**Seattle
Design
Commission**

MINUTES OF THE MEETING

19 June 2003

Projects Reviewed

South Lake Union Park plan

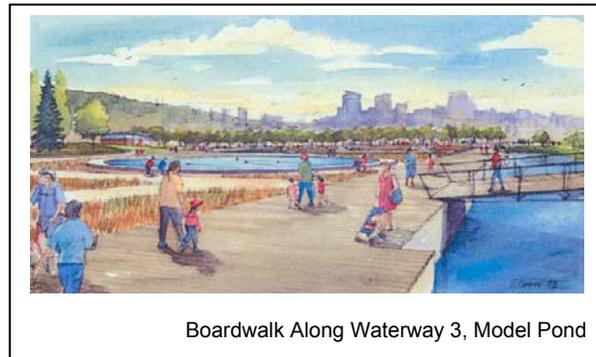
- Notes that the seasonal planting area is large and would like to know what is meant by seasonal plantings.
 - Proponents stated that the lawn and pond will not be very usable for a good part of the year, so seasonal plantings will provide interest and express variety. Proponents further stated that the lawn can be mown to be used in high-capacity events.

- Would like to know where the prevailing winds are coming from and how strong they are.
 - Proponents stated that they come from the northwest and the location of the model pond was determined by that. While some spaces are open, others on the west side are more intimate and protected.

- Would like to know if the perched wetlands will provide salmon habitat.
 - Proponents stated that, for the canal itself, it is more about now to not create predator habitat rather than how to create salmon habitat. To do this, the team must not create a lot of shade, so having the terraces float is not the best solution because it creates predator habitat. The stormwater wetland in the northwest corner will treat water from the parking lot and the hope is that they will be able to create a wetland edge for salmon.

- Hopes that, over time, the original plans can be adhered to, especially with the edge conditions; supports the edges as they are drawn—without railings and barriers.

- Would like to know what is happening with the southwest edge.
 - Proponents stated that it needs to be stronger and is where the streetcar stop will be. It will be a simple, plaza-like space and they will keep the view. SDOT is still working out the details of how that corner will work.
